Project Name : Sea Road, Rustington

Note Title : Drainage Technical Note

1.1.2 This note will support submission of documents aiming at addressing outstanding comments relating to the drainage condition discharge application ref: R/20/24/DOC.

Drawing 25-043-SK001

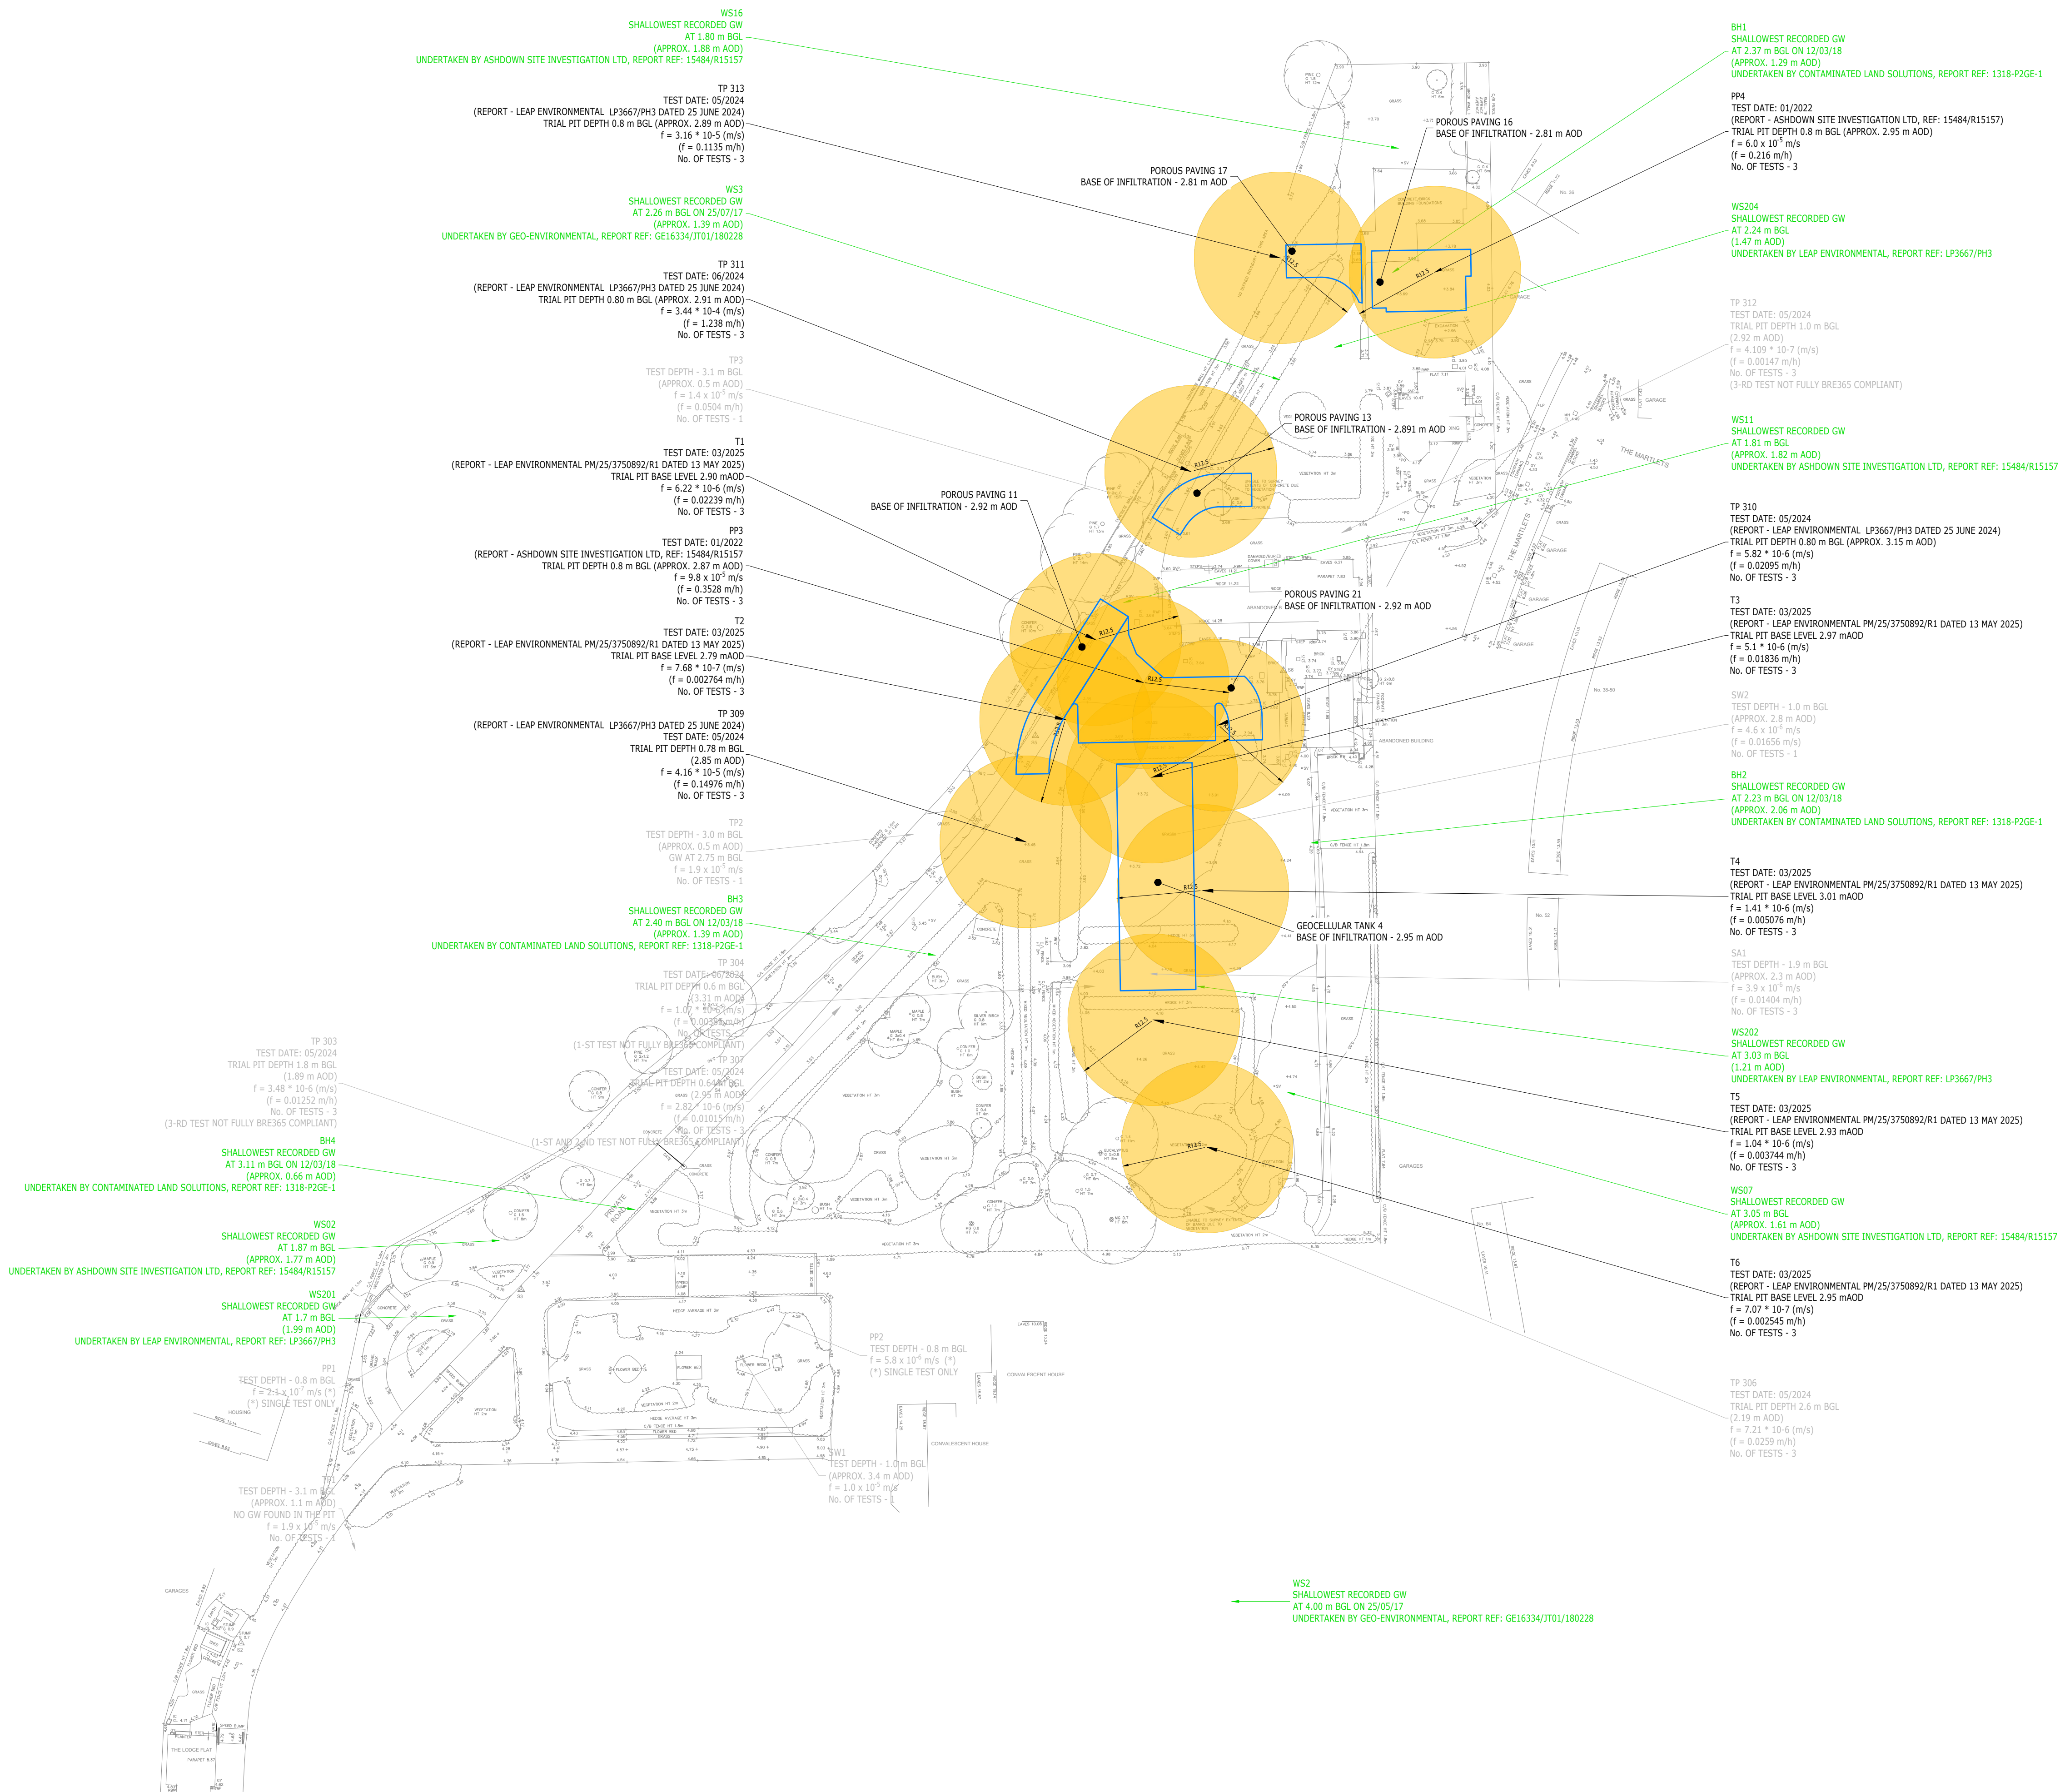
“I have reviewed SK001 Rev B, noting the presentation of this drawing differs to the last issue. All testing data is annotated; however, the light grey text needs to be clearer.

Noting the geology and differing results, a more cautious approach is recommended; I have suggested the following approach:

- Tank 4, PP 11 & Tank 5 to use worst case of 0.02173m/h.
- PP 16 & 17 to use worst case of 0.1135m/h.
- PP 13 yields a significantly higher rate not replicated anywhere else, therefore suggest using worst case of 0.1135m/h to match the other PP's.

Noting 3 No tests were completed to BRE365 at each location and the above approach for design rates, no further safety factor need to applied to the calcs.”

1. PROPOSED INFILTRATION RATES :
 - a. GEOCELLULAR TANK 4 - 0.00374 m/h (AS PER TS)
 - b. POROUS PAVING 11 - 0.002764 m/h (AS PER T2)
 - c. POROUS PAVING 13 - 0.1135 m/h - AS PER ARUN CD ADVICE

- d. POROUS PAVING 16 - 0.1135 m/h - AS PER ARUN CD ADVICE
 - e. POROUS PAVING 17 - 0.1135 m/h - AS PER ARUN CD ADVICE
 - f. POROUS PAVING 21 - 0.002764 m/h (AS PER T2)
